Committee of Adjustment Report – Kapsalakis

Report Number COA2024-028

Subject: The purpose and effect is to facilitate the demolition of the existing boathouse and the construction of a new larger boathouse.

The variance is requested at **80 Romany Ranch Road** (File D20-2024-018).

APPLICANT'S SKETCH

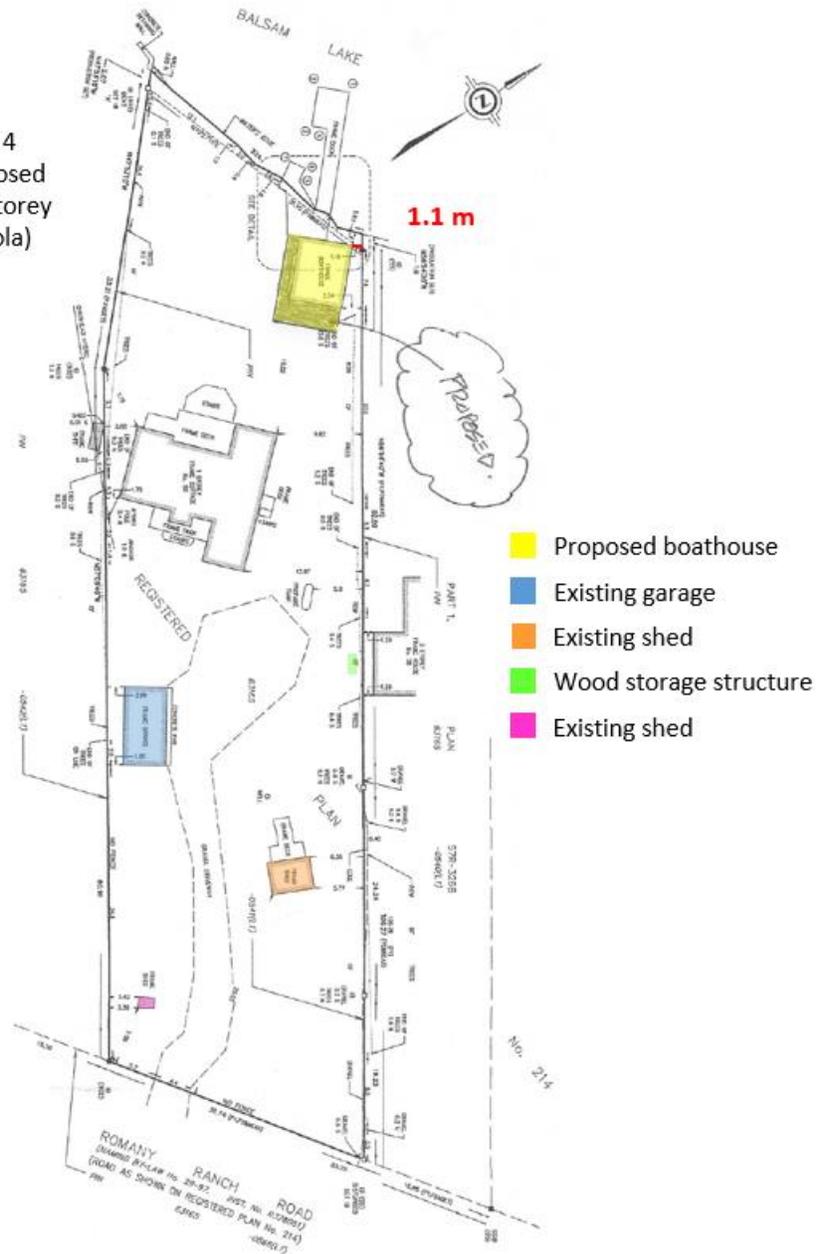
Recommended that reliefs 1 and 4 be **GRANTED**, provided the proposed boathouse is limited to a single storey (and may include a rooftop pergola)
